## Improved Gear Pump For Cummins Select

DIPACO now has available an improved gear pump for the Cummins Select fuel pump assembly. The D4954880 gear pump replaces the D4010324 gear pump as well as all previous versions on N14, L10, M11 ISM, ISMe and QSM engines using the Select fuel system.

**D4010324 (Old Style)**

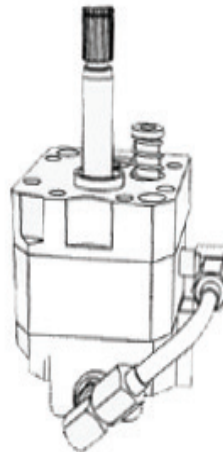
The older D4010324 gear pump used an external cooling pipe and a check valve. The improved D4954880 gear pump added internal drilling which eliminated the need for an external cooling pipe.
